**ADDENDUM NO. 7**  
**RFQ 211782**

The following changes and/or additions shall be made to the original Invitation for Bid No. RFQ 211782, Construction of the New Loudoun County Juvenile Detention Center. Please acknowledge receipt of this addendum by signing and returning with your bid.

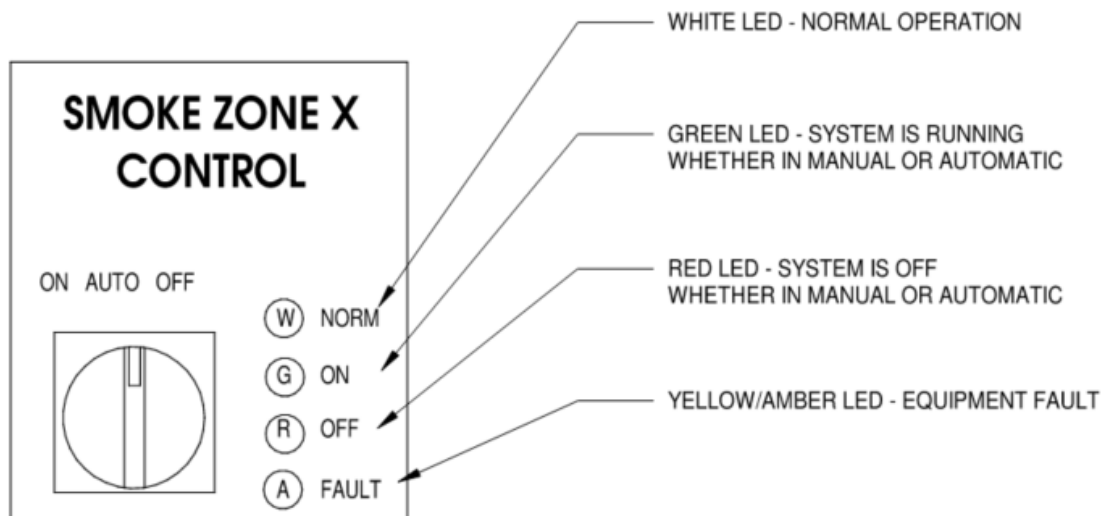
**Question 2:** Details of the Smoke Control panel are missing from dwgs. Please provide information regarding the qty of HOA switches and indicators for eqmt to be reflected on the panel. Does the panel require controls for fans only or do all dampers require individual controls?

**Answer:** Firefighters smoke control panel shall have Zone control switches for each smoke zone within the building. Enclosure shall be recessed welded steel with baked enamel finish. The cover shall be locking and have a full viewing window. The panel shall provide the entire building floor plan and indicate the smoke zones appropriately. All dampers require individual controls.
